FCS FISCHER, LTD.  
86.73 ACRE TRACT  
MASTER DEVELOPMENT PLAN

JOB NO. 4763-70  
DATE MAY 2005  
DESIGNER AKP  
CHECKED SLW DRAWN AKP  
SHEET C1.00

**Subject: Master Development Plan FCS Fischer, Ltd. 86.73 Acre Tract, A/P #1132014**

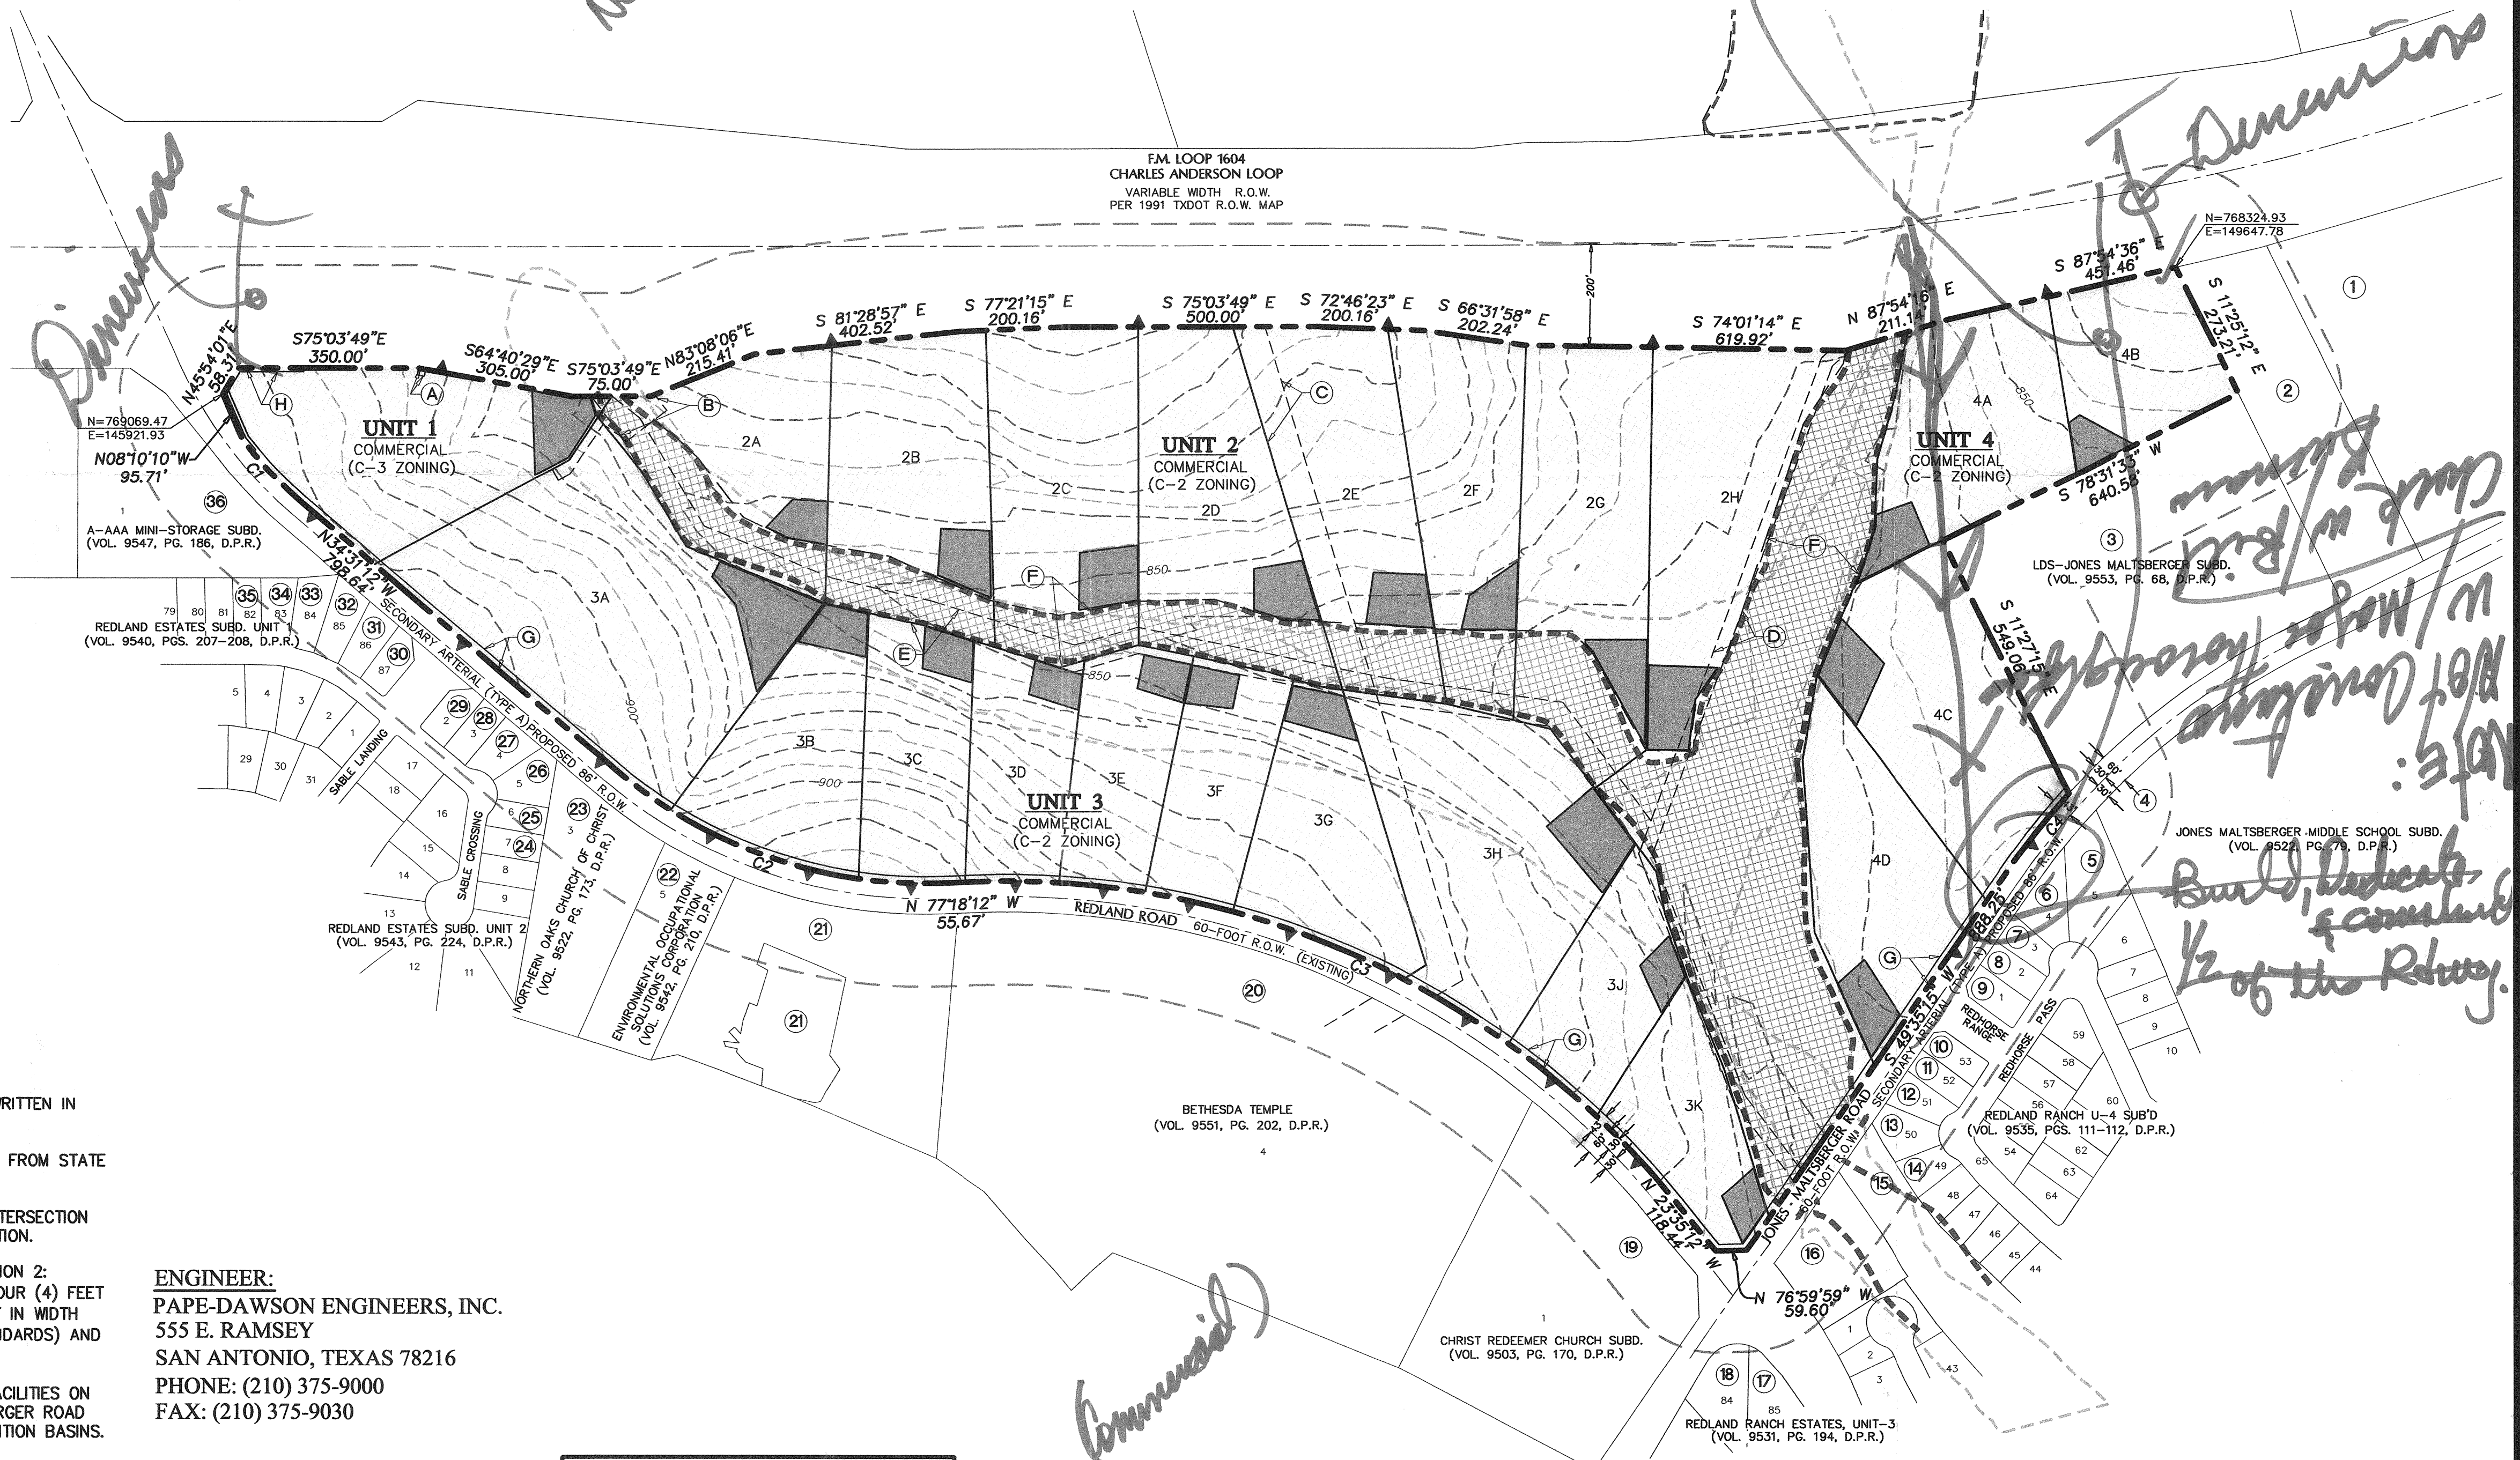
- PROVIDE A LETTER FROM TX DOT.
- SHOW DIMENSION ~~ON~~ TO FM 1604 FROM THE FAR OUT SIDE PROPERTY CORNERS.

Comment added to MDP Plan "The MDP Developable area shown totals 73.47 acres. However, the total allowable impervious cover for this property is limited to 71.64 acres per a previous written agreement with SAWS. Therefore, it can be concluded that the ultimate development of this property will be adjusted so as not to exceed the allowable impervious cover for 71.64 acres."

X Other: Please add the following tree species: condalia, Post oak, Mesquite, Huisache.

X      Other: On the TREE STAND DELINEATION PLAN please remove note #3,

Also, please add the following trees species to the dominant trees: Post oak, Mesquite, Huisache, Condalia and Hackberry

1. SHOW the dimensions of and approximate locations of the existing Redland Road and Jones-Maltsberger Road culvert crossings.
2. SHOW (and/or label) the approximate locations of Detention Ponds and TCEQ Water Quality Basins. (It appears that a legend note is missing.)
3. ADD "flow direction arrows" to illustrate approximate flow paths [across lots as well as with drainage easements].
4. ADD a drainage easement to allow for a drainage channel/system to direct runoff from the existing Redland Road culverts to the FEMA floodplain drainage easement.
5. ADD the following note:

6. REVISE Note No. 8 to remove reference to a "downstream drainage improvement" option.<sup>6</sup>

**The Major Thoroughfare Plan: Disapproved**  
**The Major Thoroughfare Plan indicates Jones Maltsburger as being a secondary arterial and going through the project to FM 1604. Please contact Mr. Bill Burman (207-7937) on this matter.**

1. Provide TxDot Letter
2. Show dimension to the centerline of FM 1604 from the two far corners of the project.

1. The major thoroughfare plan indicates Jones Maltsburger curves to the north and ties into FM 1604. Please correct.
2. Also label on Jones Maltsberger and Redland Road , 13' Dedication.

I do NOT recommend approval. Additional roadway detail is requested.

1. SHOW the dimensions of and approximate locations of the existing Redland Road and Jones-Maltsberger Road culvert crossings.  
*This comment is not appropriate to a master development plan exhibit. There is no requirement to show and dimension drainage structures on a master development plan exhibit. In addition, the Redland Road culvert referenced in the stormwater management plan is located approximately 1800 lf downstream of the property away from the project limits indicated on this exhibit.*

2. SHOW (and/or label) the approximate locations of Detention Ponds and TCEQ Water Quality Basins. (It appears that a legend note is missing.)  
*A legend note was added indicating the shaded areas as approximate locations of Detention Ponds. TCEQ Water Quality basins will be designed based on site-specific development plans and impervious cover. To our knowledge, there is no requirement to show TCEQ Water Quality Basins on a Master Development Plan exhibit.*

3. ADD "flow direction arrows" to illustrate approximate flow paths [across lots as well as with drainage easements].  
*This comment is not appropriate to a master development plan exhibit. To our knowledge, there is no requirement to show flow direction arrows on a master development plan exhibit.*

4. ADD a drainage easement to allow for a drainage channel/system to direct runoff from the existing Redland Road culverts to the FEMA floodplain drainage easement.  
*Two drainage easements located on both sides of Lot 3A were added to the MDP exhibit. Reference keyed note F.*

5. ADD the following note: "Some or all of this property is located in the dam breach inundation area of the San Antonio River Authority Natural Resource Conservation Service Dam No. 11 located in The Salado Creek Watershed. The dam is owned and operated by the San Antonio River Authority, which is located at 100 E. Gunther, San Antonio, Texas 78204." This note must be placed on all plats and replats associated with this property."  
*This type of note has been discussed at length between the owner and the City of San Antonio. Kindly find attached a letter from the City of San Antonio regarding this matter. In accordance with this agreement, the owner has advised us that the requested note will not be added to the MDP exhibit.*

6. REVISE Note No. 8 to remove reference to a "downstream drainage improvement" option.  
*The referenced downstream drainage improvement option was removed from Note 8.*

The net acreage listed on the MPD is net total area outside of floodplain. It is not intended to be the proposed impervious cover for the project. Landscaping requirements and easements will not allow 100% impervious cover within the net total area of the proposed development parcels. Specific areas of impervious cover will be submitted for each development parcel with the required Water Pollution Abatement Plan. The fact that the net area is within 1.83 acres of the allowable impervious cover demonstrates the intent to comply with the previous agreement. For clarification, a note was added to the Master Development Plan exhibit referencing the 71.64 acres of allowable impervious cover.

For now, we will include a note on the plan...."As required in the Bicycle Master Plan (Ordinance 100741 - approval by City Council April 21, 2005), the ultimate street section of all future collector and arterial roadways will be required to include bicycle facilities (path or lane)."
